Service Bulletin

REFRIGERATORS
SIDE-BY-SIDE PLASTIC LINER MODELS
(MODELS LISTED BELOW)

REF 05-07

REFRIGERATOR WILL NOT CARRY THE HARNESS DC CAPACITORS (WR23X10494 AND WR23X10495)

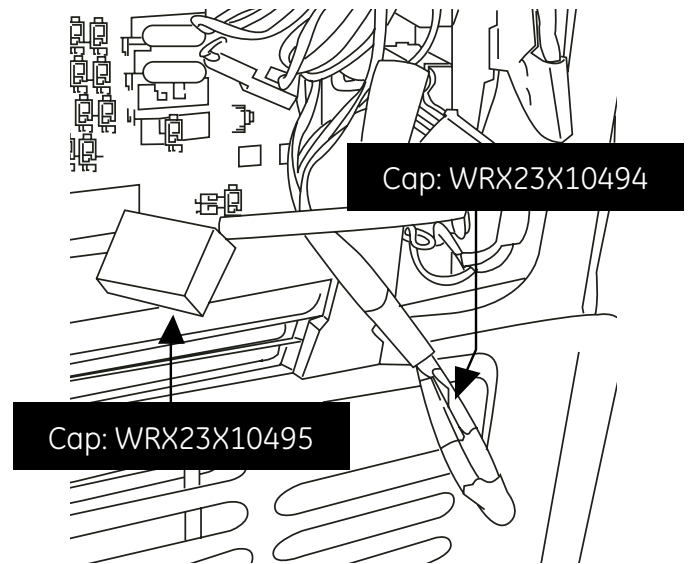
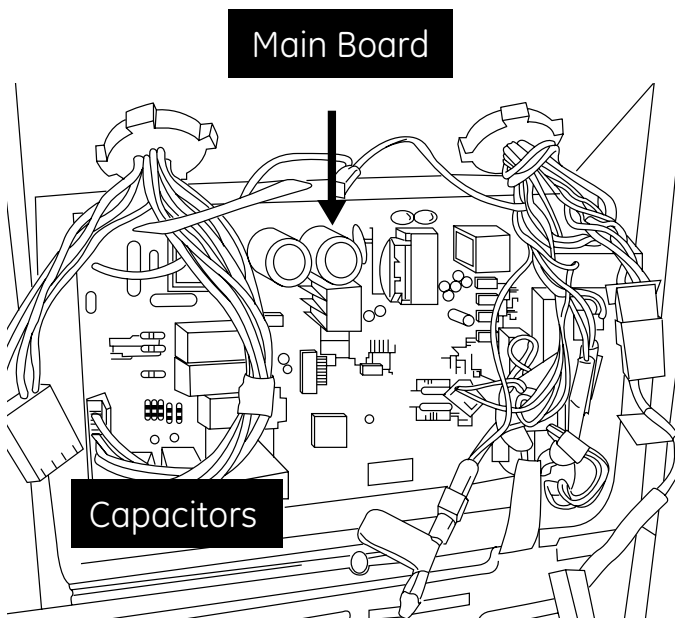
Currently there are Harness DC Capacitors (**WR23X10494** and **WR23X10495**) in the main board area on the International Side-by-Side Plastic Liner Models.

Improvements have been made in the main board and it has been determined that the EMI Noise Filters (Capacitors) will not need to be used on the units. See illustrations below:
